Authors' response to short comment by G. Sun

Figure 1. Time series plots of (left to right) rainfall, maximum temperature, minimum temperature and observed streamflow with associated trend line for (a) Upstream, (b) Midstream and (c) Downstream regions of the UGB

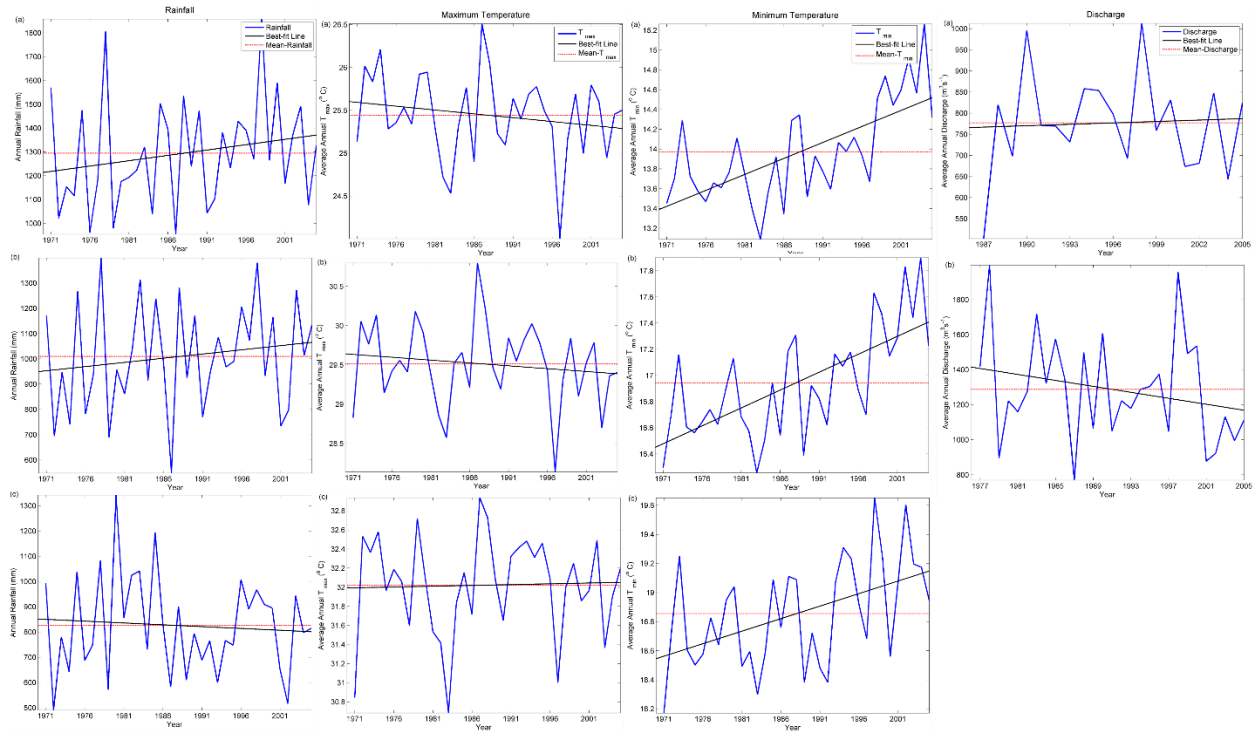
C2: 'Has the hydrology changed over the period 1970-2011? Has climate changed? It is unclear from the write-up to me. If the hydrology has changed (I assume so given the large change is LU), can the VIC model explained it based on your study.'

AR: Based on the Mann-Kendall trend test conducted on climate variables and observed streamflow, it is noticed that climate variables such as rainfall and maximum temperature did not change significantly (95% confidence level) from 1971-2005. However, minimum temperature is observed to show an increasing trend during the same period. Observed streamflow for upstream (1987-2005) and midstream (1977-2005) regions did not show any trend. The corresponding results are presented as time series plots in Fig. 1. This observation can be directly related to the results shown in the paper where climate change (not LU) is observed to be predominant factor affecting the hydrologic response. It is observed that even though LU has changed significantly during the baseline time period, its influence on hydrologic response is not very dominant. This could be due to low spatial extent of the sensitive LU category (urban area) in the region (Pg. 2220 (24-27) and Pg. 2221 (1-11)).
